FOR PUBLIC HEARING  
PETITION NUMBER 2006-66

SITE PLAN  
SCALE: 1" = 20'

SITE PLAN FOR  
MT. ZION PROPERTIES, LLC.  
6010 E. W.T. HARRIS BLVD.  
CHARLOTTE, NC.

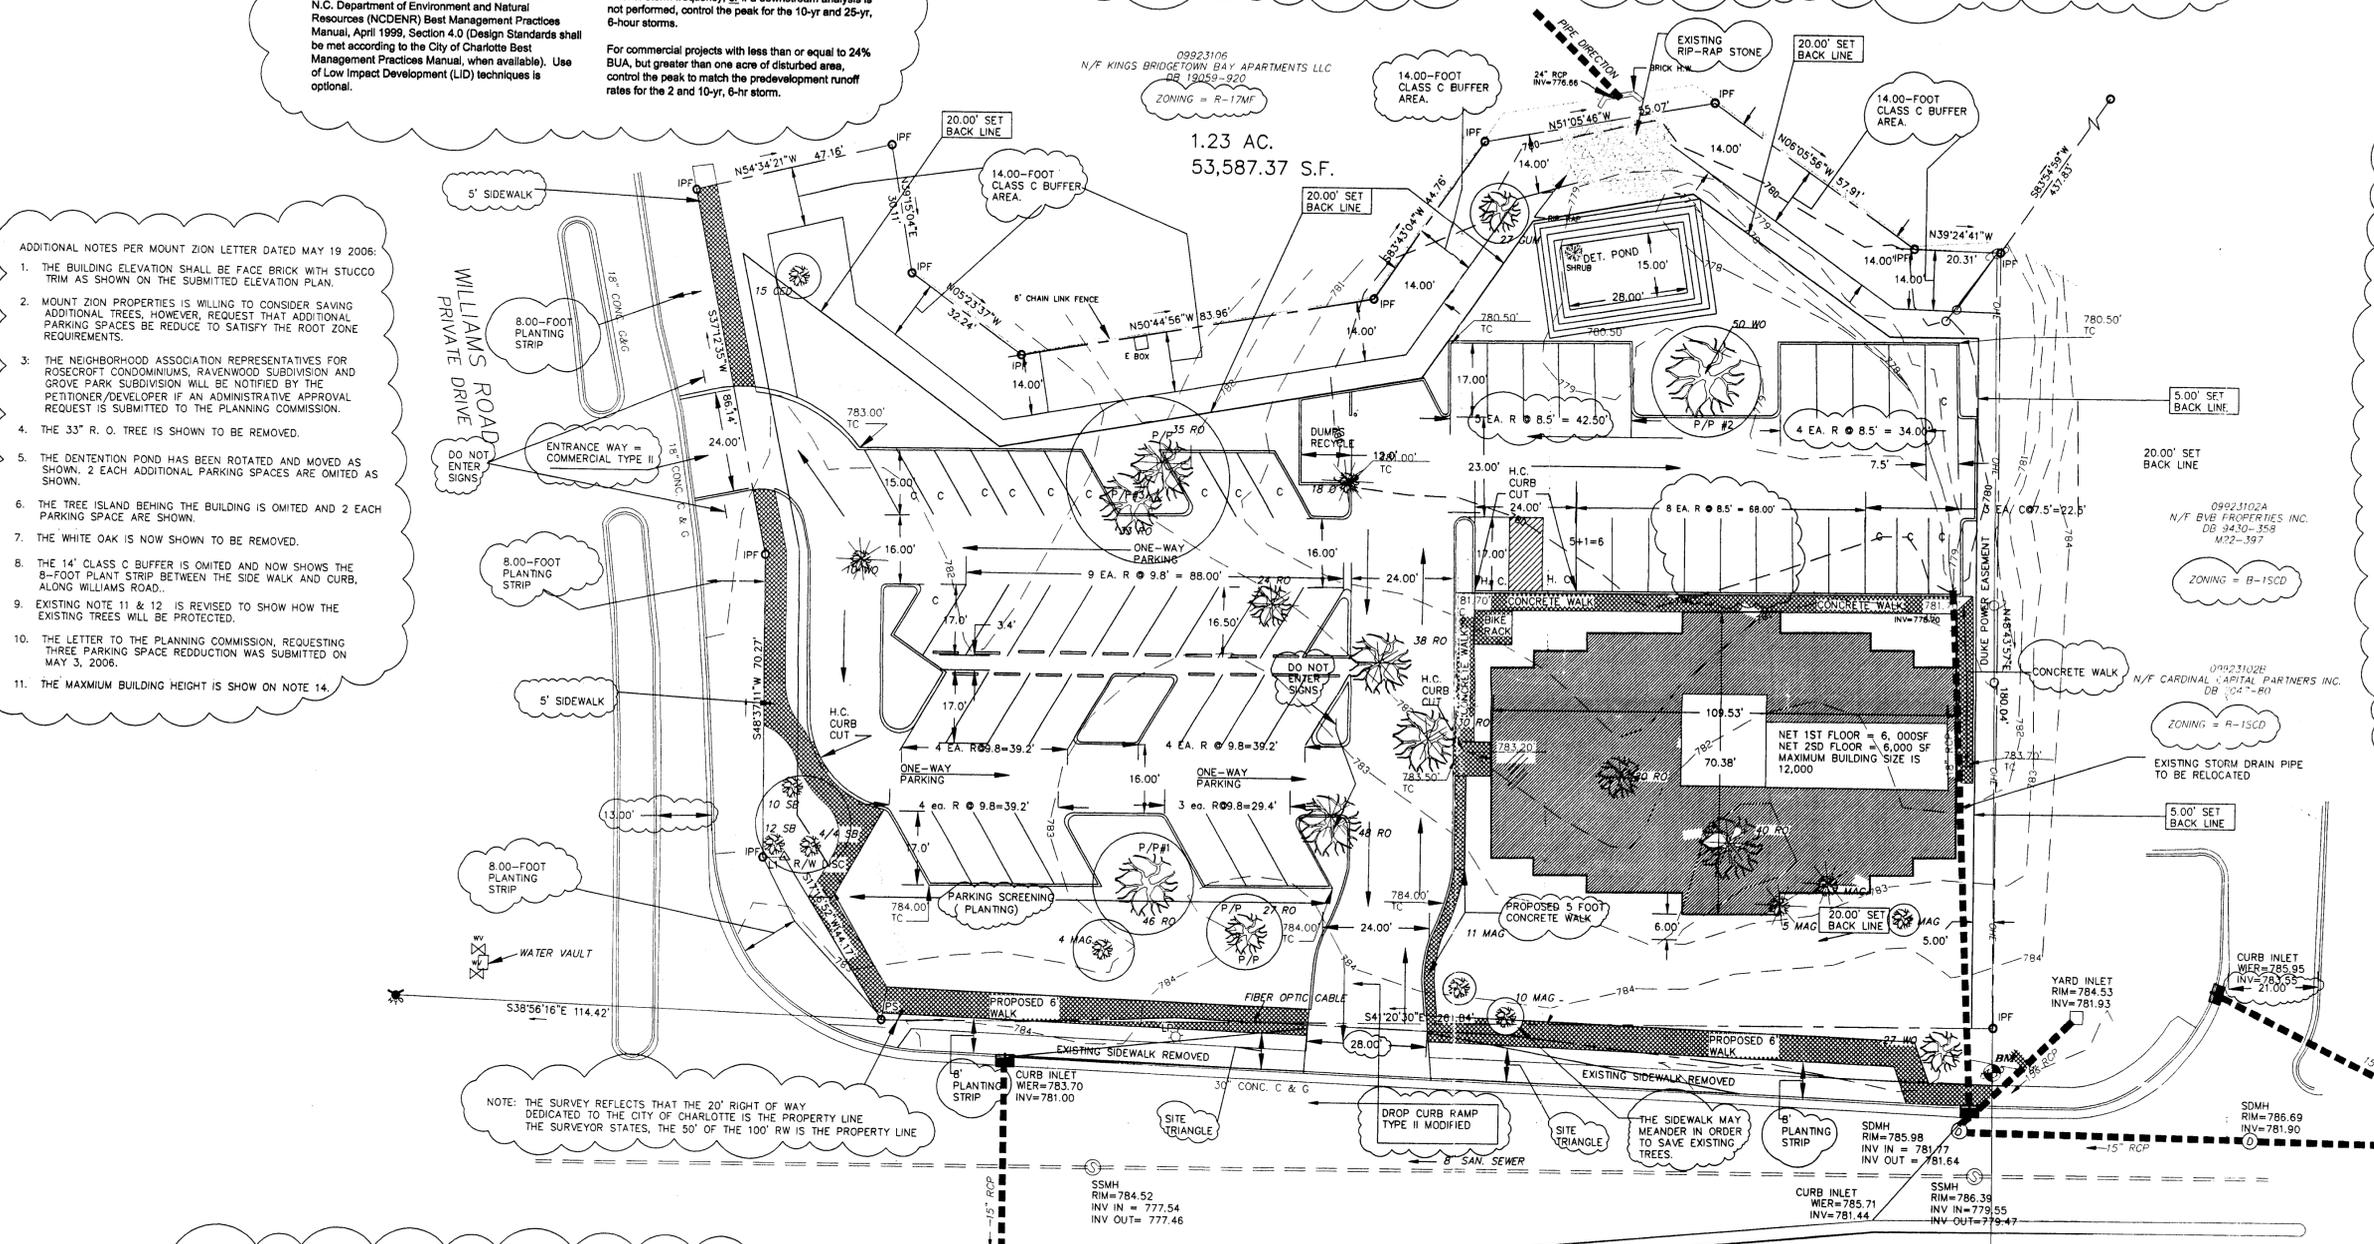
- ADDITIONAL NOTES PER MOUNT ZION LETTER DATED MAY 19 2006:
1. THE BUILDING ELEVATION SHALL BE FACE BRICK WITH STUCCO TRIM AS SHOWN ON THE SUBMITTED ELEVATION PLAN.

2. MOUNT ZION PROPERTIES IS WILLING TO CONSIDER SAVING ADDITIONAL TREES, HOWEVER, REQUEST THAT ADDITIONAL PARKING SPACES BE REDUCED TO SATISFY THE ROOT ZONE REQUIREMENTS.

4. THE 33" R. O. TREE IS SHOWN TO BE REMOVED.
  5. THE DENTENTION POND HAS BEEN ROTATED AND MOVED AS SHOWN, 2 EACH ADDITIONAL PARKING SPACES ARE OMITTED AS SHOWN.

6. THE TREE ISLAND BEHIND THE BUILDING IS OMITTED AND 2 EACH PARKING SPACE ARE SHOWN.
  7. THE WHITE OAK IS NOW SHOWN TO BE REMOVED.
  8. THE 14' CLASS C BUFFER IS OMITTED AND NOW SHOWS THE 8-FOOT PLANT STRIP BETWEEN THE SIDE WALK AND CURB, ALONG WILLIAMS ROAD.

9. EXISTING NOTE 11 & 12 IS REVISED TO SHOW HOW THE EXISTING TREES WILL BE PROTECTED.
  10. THE LETTER TO THE PLANNING COMMISSION, REQUESTING THREE PARKING SPACE REDUCTION WAS SUBMITTED ON MAY 3, 2006.

11. THE MAXIMUM BUILDING HEIGHT IS SHOW ON NOTE 14.
